LEMON CREEK RANCH PHASE 1A WATER AND SEWER
Solicitation Number: CO-00475
Job No.: 21-1037 and 21-1531

ADDENDUM 1
September 3, 2021

**INSTALLATION OF PIPE IN CASING
OPEN CUT OR JACK AND BORE**

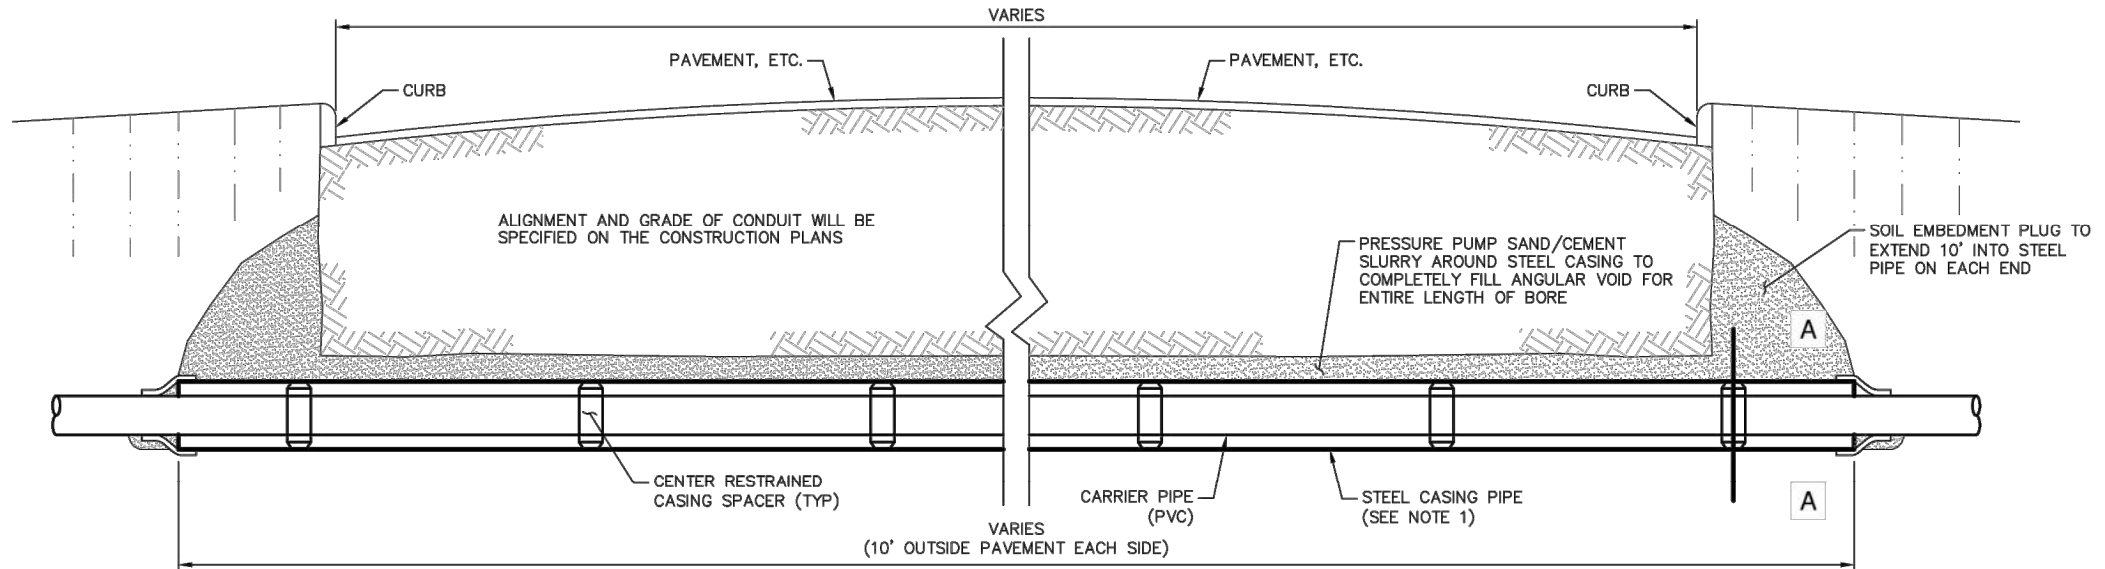
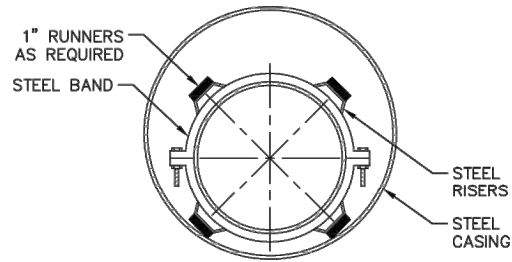
8. **Question: We are a steel casing supplier and would like to bid on that aspect of this job. After reviewing the plans and specifications, I was unable to find specifics regarding the steel casing such as wall thickness, ASTM grade, and PSI strength. Would you happen to have any of this information?**

Response: See the attached "Installation of Pipe in Casing Open Cut or Jack and Bore" detail for reference.
